RS-06-185

Clinton Power Station, Unit 1
Facility Operating License No. NPF-62
NRC Docket No. 50-461

Subject: Additional Information Supporting the Request for NRC Approval of Changes to the Clinton Power Station Emergency Plan Annex

Figure F-1: Exelon Notification Scheme (For Full Augmentation)

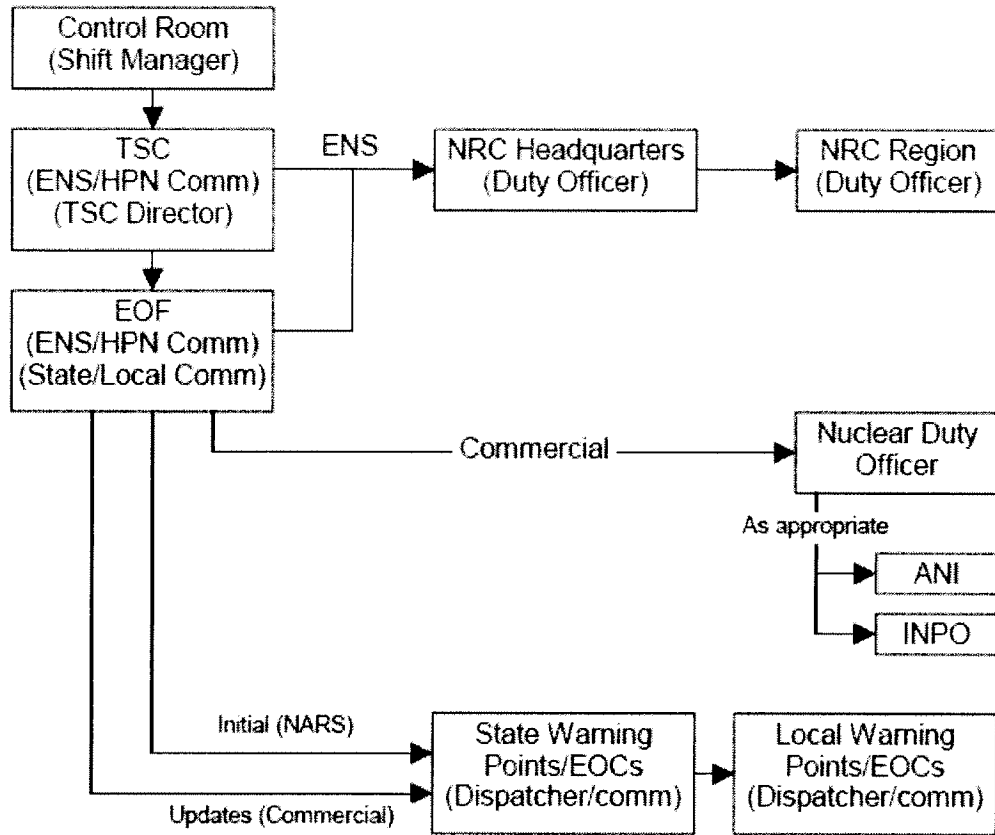
Will Clinton's emergency plan have the same level of detail as change #1.M in your 10 CFR 50.54(q) evaluation?

Figure F-1 (attached) depicts the initial notification paths and the organizational titles from the Exelon Nuclear Emergency Response Facilities (ERFs) to federal, state and local emergency response organizations, and industry support agencies. The Exelon primary and alternate methods of communication, and the NRC communications network, are illustrated on Figures F-2 and F-3 (attached).
